TRANS/WP.29/GRE/2002/45
23 July 2002

PROPOSAL FOR DRAFT AMENDMENTS TO DRAFT REGULATION ON ADAPTATIVE FRONT-LIGHTING SYSTEM (AFS)

Transmitted by the Expert from Poland

<u>Note</u>: The text reproduced below was prepared by the expert from Poland, in order to change the co-ordinate system for defining photometric requirements from 25 m screen to road level surface (RS) and surface at the eye-level of the glare exposed drivers (GS) "First step". It refers to document TRANS/WP.29/GRE/2002/18.

"Fig. 1. Points position on the road surface (RS).

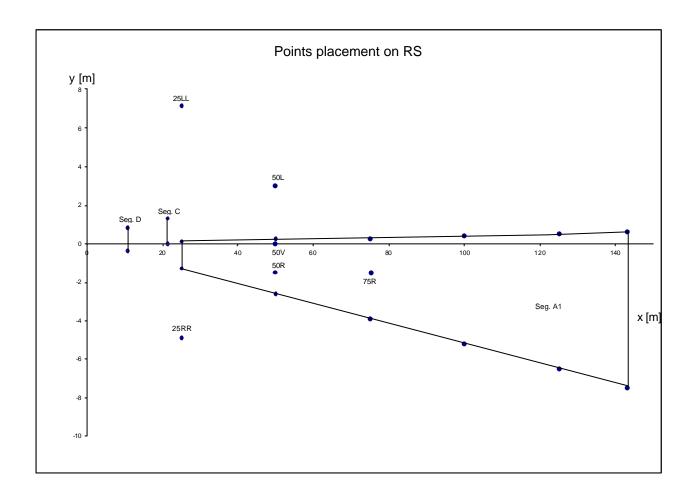
Insert new figures 1 and 2 and tables 1 to 2, to read:
